ACCESSIBILITY ASSESSMENT

January 19, 2024

ADA TITLE II ASSESSMENT

Field Elementary School
3600 East Sierra Madre Boulevard
Pasadena, California 91107

Photos for Barrier ID: AX415204

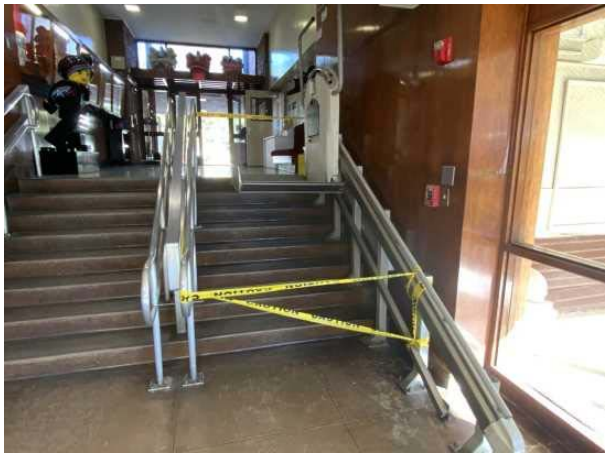
Assembly	Accessible Parking
Type	Parking Space - Van
ADA Standard	California Building Code Chap 11B-502.4
Barrier Detail	CALIFORNIA: The van parking aisle slope is greater than 1:48 (2.08%).
Location Description	Access Aisle Serving P1-A & P1-B
Observed	Nov 29, 2023 by javondrick.orange@bureauveritas.com
Site Conditions	Access aisle has a cross slope of 3.1%.

Photos for Barrier ID: AX425573

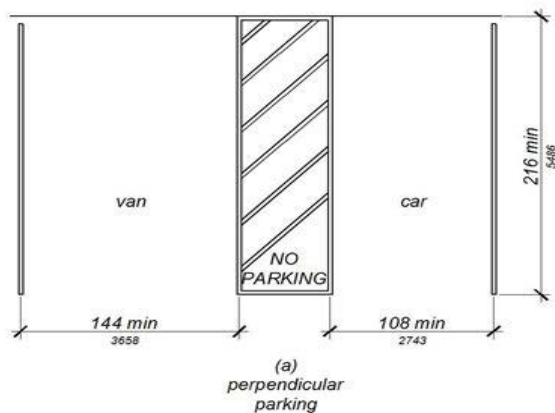
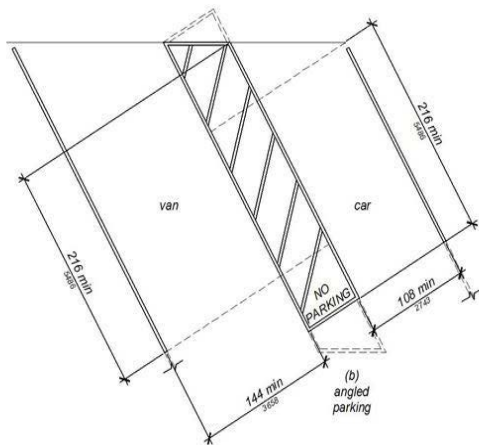
Assembly	Accessible Parking
Type	Parking Space - Van
ADA Standard	California Building Code Chap 11B-502.4
Barrier Detail	CALIFORNIA: The van parking stall slope is greater than 1:48 (2.08%).
Location Description	Accessible Parking Space P1-A
Observed	Nov 28, 2023 by javondrick.orange@bureauveritas.com
Site Conditions	The van accessible parking space running slope is 2.7%.
Resolution	Install a van stall with maximum slope 1:48 (2.08%). Van stalls shall be level. Changes in level are not permitted. [Exception: Slopes not steeper than 1:48 shall be permitted.] The quantity and order of magnitude cost estimate provided for this barrier are limited to the extent of the area identified as non-compliant. Additional costs that may be associated with removing and repairing the barrier are not included.
Quantity	1 EA
Priority	1

Photos for Barrier ID: AX415301

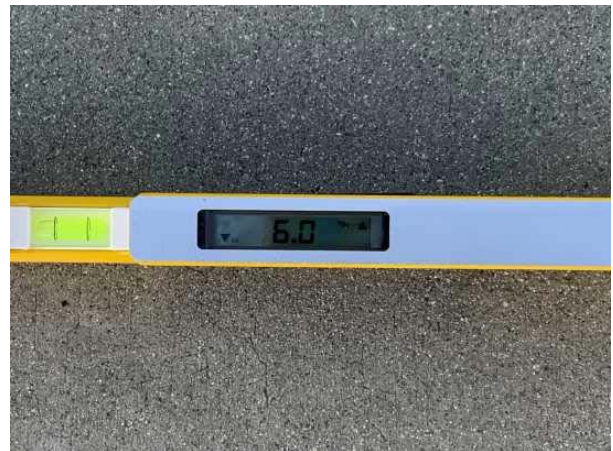
Assembly	Exterior Access Route
Type	Exterior Accessible Route
ADA Standard	California Building Code Chap 11B-403.3, 403.5
Barrier Detail	
CALIFORNIA: The exterior accessible route has slopes in excess of maximum 1:20 (5%) running slope and/or maximum 1:48 (2.08)% cross slope.	
Location Description	Accessible Route from Accessible Parking
Observed	Nov 28, 2023 by javondrick.orange@bureauveritas.com
Site Conditions	The accessible route has a running slope of 5.8% for 5' in length by 5' wide.
Resolution	
Install a compliant exterior accessible route. An exterior accessible route has maximum 1:20 (5%) running slope and maximum 1:48 (2.08%) cross slope. The minimum clear width of an exterior accessible route is 48". [EXCEPTION: Where rights-of-way, natural barriers or other existing conditions are present, the enforcing agency may determine that compliance with the 48" minimum clear width would create an unreasonable hardship. If the enforcing agency determines that an unreasonable hardship exists, the clear width may be reduced to 36" minimum.] [ADVISORY 11B-403.3 Slope. When the running slope of a walking surface exceeds 5%, it must comply with the accessibility requirements for ramps.] Where grading to maximum running slope of 1:20 (5% running slope) is not possible, provide a compliant ramped surface within the walkway with maximum slope 1:12 (8.33%) and maximum ramp run rise of 6" without handrails. If a ramped surface with running slopes greater than 1:20 (5%) and maximum 1:12 (8.33%) rises more than 6", handrails are required. The cost estimate for this barrier removal is based on grading the running slope to maximum 1:20 (5%). The quantity and order of magnitude cost estimate provided for this barrier are limited to the extent of the area identified as non-compliant. Additional costs that may be associated with removal of the barrier are not included.

Photos for Barrier ID: AX415287

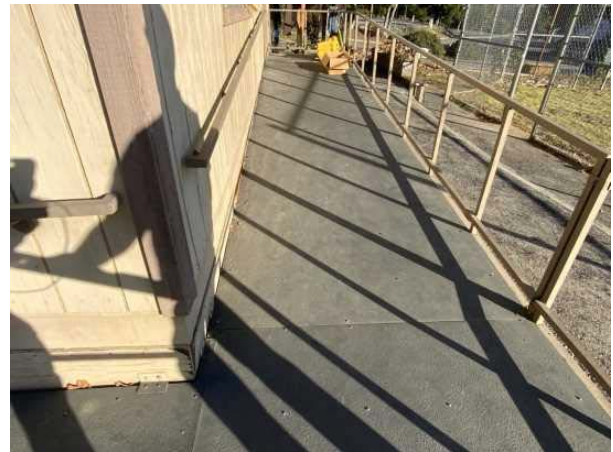
Assembly	Exterior Access Route
Type	Ramp
ADA Standard	California Building Code Chap 11B-Chap 11B-405.7
Barrier Detail	CALIFORNIA: The ramp landings are not compliant.
Location Description	I26
Observed	Nov 28, 2023 by javondrick.orange@bureauveritas.com
Site Conditions	There are stored items in the landing of the ramp.
Resolution	
Remove stored items to provide compliant ramp landings. Ramp landings at bottom of ramp runs shall be minimum 72" length in the direction of the ramp run, minimum 60" wide, and at least as wide as the ramp run. Ramp landings at the top of the ramp shall be 60" minimum length and 60" minimum wide. Ramp landings in the middle of the ramp, where landings are not at a turn shall be 60" minimum length and 60" minimum wide, and at least as wide as ramp. Ramp landings at turns shall be 60" minimum wide by 72" minimum length in the direction of downward travel from the upper ramp run. The maximum rise of a ramp run shall be 30". Doors which overlap landings shall project into required landing widths 3" maximum when fully open. Doors in any position shall allow minimum 42" width and depth of the landing. Ramp landings shall be level with no more than 2% slope in any direction. [Exception: Slopes not steeper than 1:48 shall be permitted.]

Photos for Barrier ID: AX415289

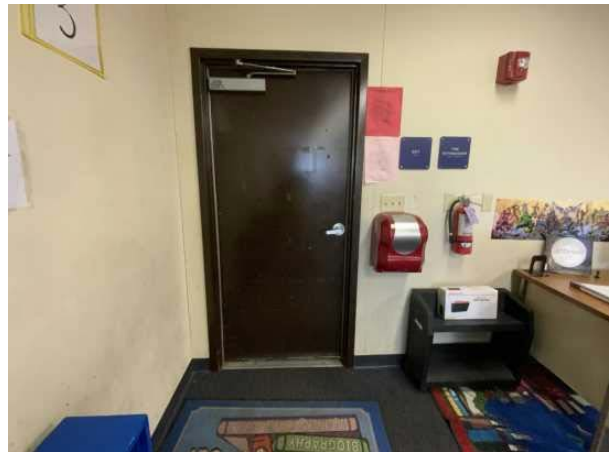
Assembly	Entrance to Building
Type	Building Entrance - Door
ADA Standard	404.2.8
Barrier Detail	
The accessible door with door closer has a sweep period of less than 5 seconds from 90 degrees to a position 12 degrees from latch.	
Location Description	L27
Observed	Nov 29, 2023 by javondrick.orange@bureauveritas.com
Site Conditions	
The closing speed is 1.70 seconds from 90 degrees to a position 12 degrees from latch.	
Resolution	
Adjust closer or remove and replace closer to ensure that the door has a closure time of at least 5 seconds within 12 degrees of the latch. Door closers and gate closers shall be adjusted so that from an open position of 90 degrees, the time required to move the door to a position of 12 degrees from the latch is 5 seconds minimum.	
Quantity	
1 EA	
Priority	1

Photos for Barrier ID: AX415249

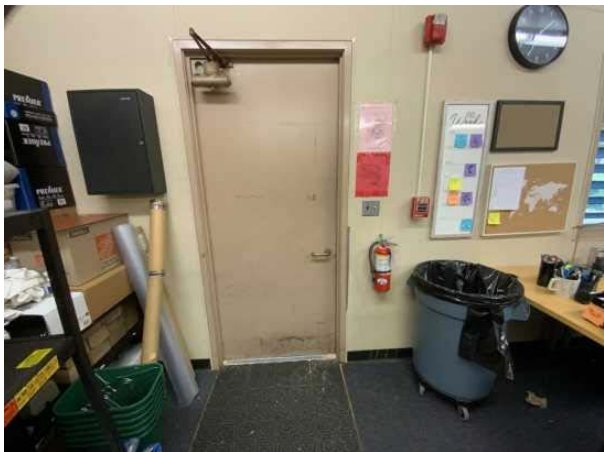
Assembly	Exterior Access Route
Type	Ramp
ADA Standard	California Building Code Chap 11B-405
Barrier Detail	CALIFORNIA: The ramp has running slopes and/or rises in excess of 1:12.
Location Description	L27
Observed	Nov 28, 2023 by javondrick.orange@bureauveritas.com
Site Conditions	The ramp has a running slope of 9.5%.
Highest Running Slope	9.5%
Resolution	
The ramp should be removed and an accessible ramp should be installed. Ramp runs shall have a running slope not steeper than 1:12. Cross slopes shall not be steeper than 1:48. The maximum rise of a ramp run shall be 30". The ramp shall have 48" minimum clear width. Ramp landings at bottom of ramp runs shall be minimum 72" length in the direction of the ramp run, and min. 60" wide and at least as wide as the ramp run. Ramp landings at the top of ramps shall be 60" minimum by 60" minimum. Ramp landings located between ramp runs, where landings are not at a turn in direction shall be 60" minimum length and 60" minimum wide, and at least as wide as ramp. Ramp landings at turns shall be 60" min. wide by 72" min. length in the direction of downward travel from the upper ramp run. Doors which overlap landings shall project into required landing widths 3" maximum when fully open. Doors in any position shall allow minimum 42" width and depth of the landing. Ramp landings shall be level with no more than 2% slope in any direction. Ramps and their approaches shall be designed so that water will not accumulate on walking surfaces. All ramp runs shall have handrails on each side of the ramp. [Exception: A door landings, handrails are not required on ramp runs less than 6" in rise or minimum 72" in length.]

Photos for Barrier ID: AX426395

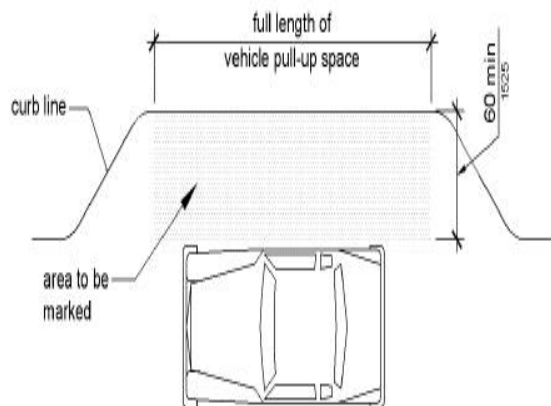
Assembly	Exterior Access Route
Type	Exterior Accessible Route
ADA Standard	303
Barrier Detail	
Sidewalk has areas of vertical level changes in excess of 1/4" that are not ramped.	
Location Description	Playground 1
Observed	Nov 28, 2023 by javondrick.orange@bureauveritas.com
Site Conditions	There is a 1 1/4" vertical change in level along the accessible route.
Resolution	
The sidewalk should be removed (sections that are heaved, cracked etc) and repaired. Changes in level of 1/4" high maximum shall be permitted to be vertical. Changes in level between 1/4" high minimum and 1/2" high maximum shall be beveled with a slope not steeper than 1:2. Changes in level greater than 1/2" shall be ramped.	
Quantity	
15 SF	
Priority	1

Photos for Barrier ID: AX415275

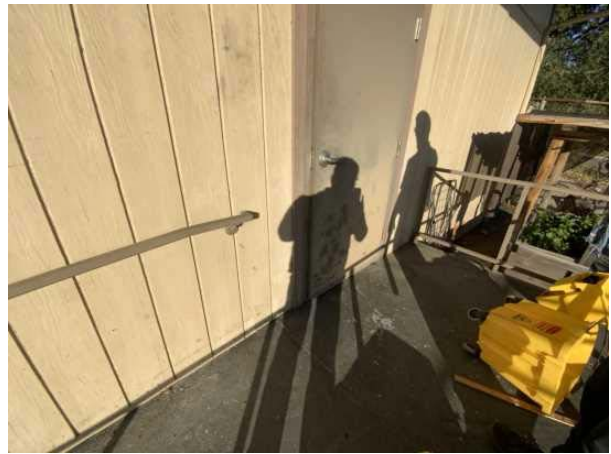
Assembly	Exterior Access Route
Type	Ramp
ADA Standard	California Building Code Chap 11B-405
Barrier Detail	CALIFORNIA: The ramp has running slopes and/or rises in excess of 1:12.
Location Description	Ramp R-1
Observed	Nov 28, 2023 by javondrick.orange@bureauveritas.com
Site Conditions	The ramp running slope is 9.3%.
Highest Running Slope	9.3%
Resolution	
The ramp should be removed and an accessible ramp should be installed. Ramp runs shall have a running slope not steeper than 1:12. Cross slopes shall not be steeper than 1:48. The maximum rise of a ramp run shall be 30". The ramp shall have 48" minimum clear width. Ramp landings at bottom of ramp runs shall be minimum 72" length in the direction of the ramp run, and min. 60" wide and at least as wide as the ramp run. Ramp landings at the top of ramps shall be 60" minimum by 60" minimum. Ramp landings located between ramp runs, where landings are not at a turn in direction shall be 60" minimum length and 60" minimum wide, and at least as wide as ramp. Ramp landings at turns shall be 60" min. wide by 72" min. length in the direction of downward travel from the upper ramp run. Doors which overlap landings shall project into required landing widths 3" maximum when fully open. Doors in any position shall allow minimum 42" width and depth of the landing. Ramp landings shall be level with no more than 2% slope in any direction. Ramps and their approaches shall be designed so that water will not accumulate on walking surfaces. All ramp runs shall have handrails on each side of the ramp. [Exception: A door landings, handrails are not required on ramp runs less than 6" in rise or minimum 72" in length.]

Photos for Barrier ID: AX415230

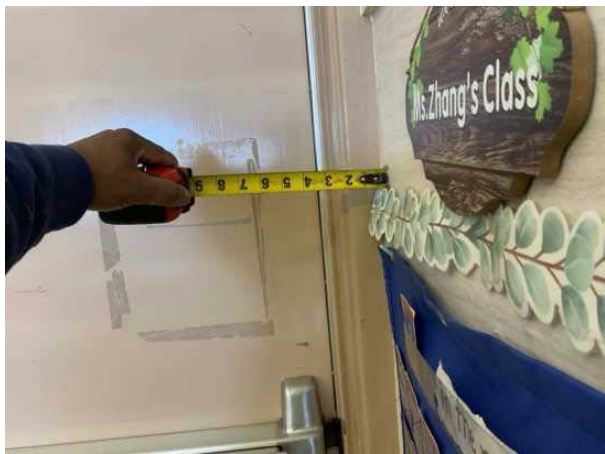
Assembly	Interior Access Route
Type	Door
ADA Standard	404.2.4; Table 404.2.4.1
Barrier Detail	
The push side of the accessible door does not have the required maneuvering clearances.	
Location Description	Classrooms
Observed	Nov 27, 2023 by javondrick.orange@bureauveritas.com
Site Conditions	
For a forward approach on the push side the side clearance is 0" due to stored items.	
Resolution	
Relocate stored items to provide the required maneuvering clearance on the push side the door. The required depth of the maneuvering clearance is 48" minimum. The required side clearance is 12" minimum on the latch side of the door. Maneuvering clearance shall extend the full width of the doorway and the required latch side clearance. Floor or ground space within the required maneuvering clearance shall be maximum 1:48 (2.08%) slope. Changes in level are not permitted.	
Quantity	
20 EA	
Priority	2

Photos for Barrier ID: AX415290

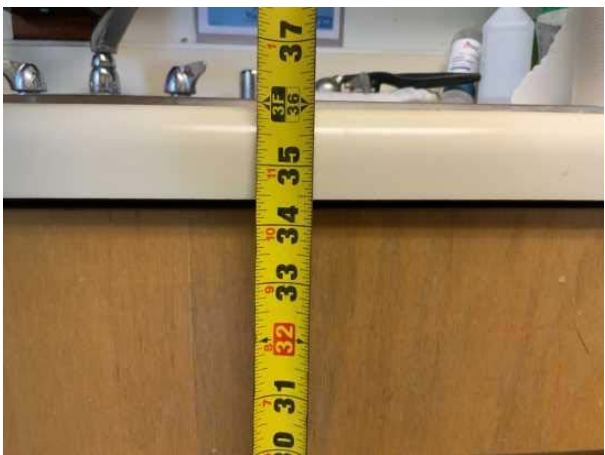
Assembly	Kitchen
Type	Sink
ADA Standard	606.3
Barrier Detail	
The accessible sink is not installed with the front of the higher of the rim or counter surface 34" maximum above finished floor.	
Location Description	I26 Kitchen
Observed	Nov 29, 2023 by javondrick.orange@bureauveritas.com
Site Conditions	The sink rim is 36 1/8" above the floor.
Resolution	
Reconfigure the sink so that the accessible sink is installed with the front of the higher of the rim or counter surface 34" maximum above finished floor.	
Quantity	
1 EA	
Priority	2

Photos for Barrier ID: AX415187

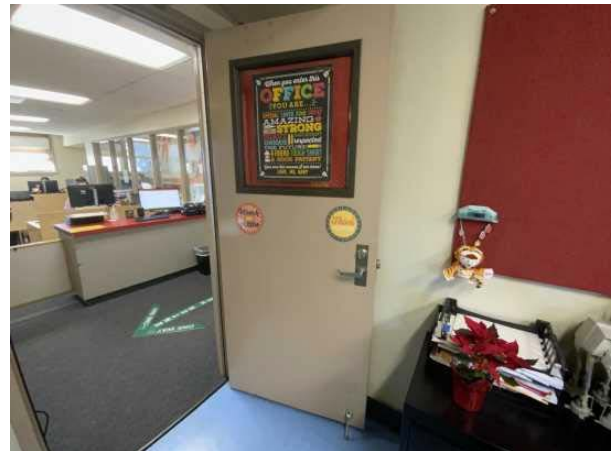
Assembly	Interior Access Route
Type	Door
ADA Standard	404.2.11
Barrier Detail	The bottom of the door vision light is higher than 43" and less than 66".
Location Description	Offices
Observed	Nov 27, 2023 by javondrick.orange@bureauveritas.com
Site Conditions	The bottom of the vision lights are 45" to 54 3/4" above the floor.
Resolution Provide a door with the bottom of at least one of the glazing panels located 43" maximum above the finish floor or grade. At least one of the glazing panels shall be located for viewing through the panels, if the panel is designed for viewing. [EXCEPTION: Vision lights with the lowest part more than 66" from the finish floor or ground are not required to comply.]	
Quantity 4 EA	
Priority	2

Photos for Barrier ID: AX415246

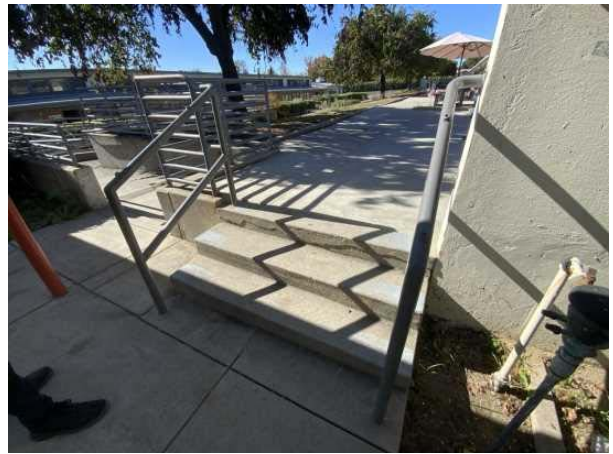
Assembly	Exterior Access Route
Type	Stairs
ADA Standard	California Building Code Chap 11B-505.10
Barrier Detail	CALIFORNIA: The stair handrail extensions are not compliant.
Location Description	Stair ST-4
Observed	Nov 28, 2023 by javondrick.orange@bureauveritas.com
Site Conditions	Handrail extensions are not provided.
Resolution	
Install compliant handrail extensions at the top and bottom of the stair flight. At the top of a stair flight, handrails shall extend horizontally above the landing for 12 inches minimum beginning directly above the first riser nosing. The handrails at the bottom of the stairs shall extend at the slope of the stair flight for a horizontal distance equal to minimum one tread depth beyond the last riser nosing and then continue 12 inches minimum horizontally at a height equal to that of the sloping portion of the rail. Extensions shall return to a wall, guard, or the landing surface, or shall be continuous to the handrail of an adjacent stair flight. [EXCEPTION: In alterations, where the extension of the handrail in the direction of stair flight would create a hazard, the extension of the handrail may be turned 90 degrees from the direction of stair flight.] [ADVISORY: It is advisable, but not required, to provide a handrail at a height designed for children. When children are the principal users in a building or facility (e.g., elementary schools), a second set of handrails at an appropriate height can assist them and aid in preventing accidents. A maximum height of 28 inches measured to the top of the gripping surface from the ramp surface or stair nosing is recommended for handrails designed for children. Sufficient vertical clearance between upper and lower handrails, 9 inches minimum, should be provided to help prevent entrapment.]

Photos for Barrier ID: AX415216

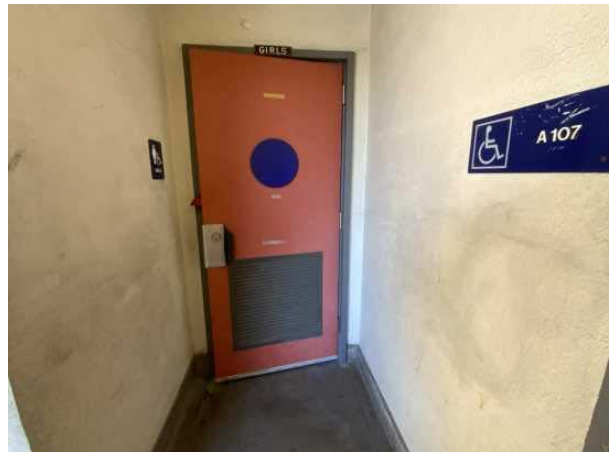
Assembly	Restroom
Type	Restroom/Bathroom-Door
ADA Standard	404.2; Table 404.2.4.1
Barrier Detail	
The pull side of the accessible door does not have the required maneuvering clearances.	
Location Description	Boys Restroom A121 and Girls Restroom A117
Observed	Nov 27, 2023 by javondrick.orange@bureauveritas.com
Site Conditions	
The maneuvering clearance beyond the latch is 6-1/2" at the pull side of the door.	
Resolution	
Redesign to provide the required maneuvering clearance at the pull side of the door. The required depth of the maneuvering clearance is 60" minimum. The required side clearance is 24" minimum on the latch side of the door. Maneuvering clearance shall extend the full width of the doorway and the required latch side clearance. Floor or ground space within the required maneuvering clearance shall be maximum 1:48 (2.08%) slope. Changes in level are not permitted.	
Quantity	
2 EA	
Priority	3
